**BEFORE THE PUBLIC SERVICE COMMISSION
OF THE STATE OF MISSOURI**

COMMENTS OF SIERRA CLUB

Figure 3: NYMEX Henry Hub Natural Gas Prices – July 27, 2011 to December 28, 2011

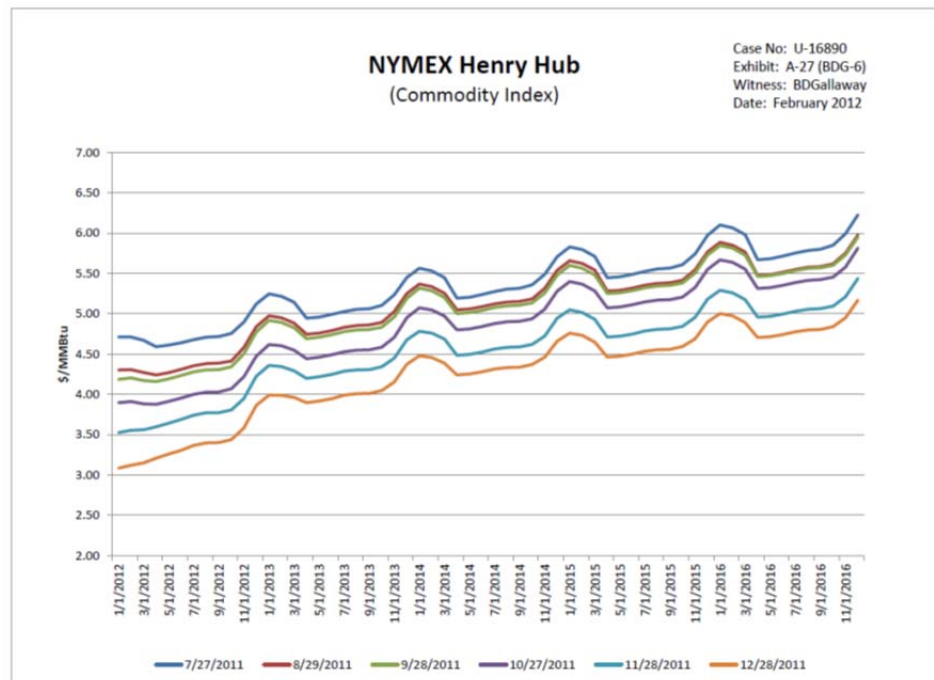
and projected natural gas prices have declined significantly over the past year or two and especially in the second half of 2011. (Biewald Test. at pp. 9-12). For example, as shown in Figure 3 below, which is a chart filed with the Michigan Public Service Commission by a witness for Consumers Energy in February 2012, projected January 1, 2012 NYMEX Henry Hub natural gas prices fell from approximately \$4.70/mmBtu on July 27, 2011 to just above \$3.00/mmBtu on December 28, 2011. The projected price for January 1, 2016 similarly fell from approximately \$6.25/mmBtu on July 27, 2011 to around \$5.10/mmBtu on December 28, 2011. Given such significant changes in natural gas prices, it was unreasonable for KCP&L to continue to rely in its April 2012 IRP on projections from December 2010 and mid-to-late 2011.

It is important to note that KCP&L was certainly aware of changing natural gas prices and acted upon those changes when it wanted to. In particular, after proposing additional DSM programs in its December 2011 MEEIA filing, KCP&L then withdrew that filing in February 2012 in part because of “low natural gas prices.” (IRP at Vol. 6, p. 6). KCP&L could have and should have incorporated those “low natural gas prices” into its April 2012 IRP filing, rather than continuing to rely on inflated price projections from 2010 and 2011.

REMEDY: KCP&L should rerun its economic modeling with up-to-date natural gas price projections, such as those from the EIA AEO 2012. At a minimum, KCP&L should exclude the ** from its natural gas price projections.

Figure 7 – State EERS Savings Targets⁴

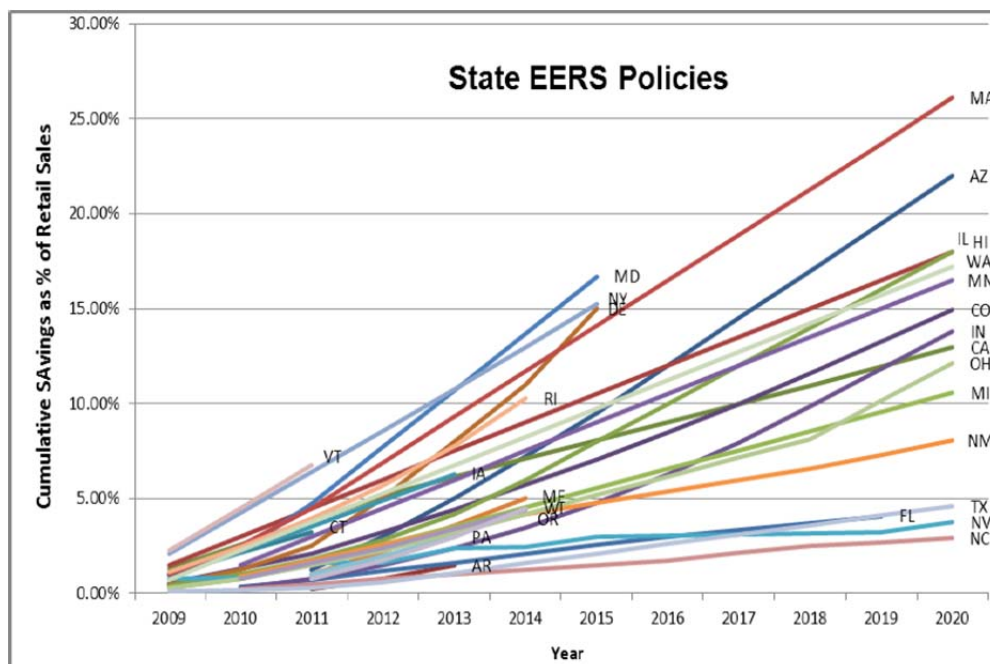
KCP&L’s contention that a 1% per year energy savings is not realistically achievable is inaccurate. As described in Section II.B above, KCP&L has provided no support for that contention, and the reality is that there are many states across the country that have established long-term aggressive energy efficiency goals that go beyond the 1% level to as much as 2 or 2.5% per year. For example, as shown in the Figure 7 below, at least 15 states have set cumulative savings goals for 2020 in excess of 10%.

Yet, KCP&L did not even attempt to determine whether it could achieve any level of energy savings over the 0.5% assumed in the DSM A portfolio. Contrary to the plain requirement of 4 CSR 240-22.050(2), 22.060(3)(A)3, KCP&L acknowledges that “a MAP portfolio was not derived, for this filing, nor were technical potentials identified.” (KCP&L Resp. to MDNR DR #2). While we are glad that the Company is finally undertaking a DSM potential study to identify RAP, MAP, and technical potential, such study was required to be done before the IRP so that the results could be incorporated into the planning process. KCP&L’s failure to do so means that the Company is proposing to go down the road of pursuing a resource plan that likely has a higher NPVRR than is necessary. Such a result is not just and reasonable, nor is it consistent with the requirements of the IRP rules.

REMEDY: KCP&L should complete an evaluation of its technical, maximum achievable, and realistic achievable energy savings potential from DSM, including CHP, and incorporate the results of such evaluation into its resource planning as part of the current IRP process.
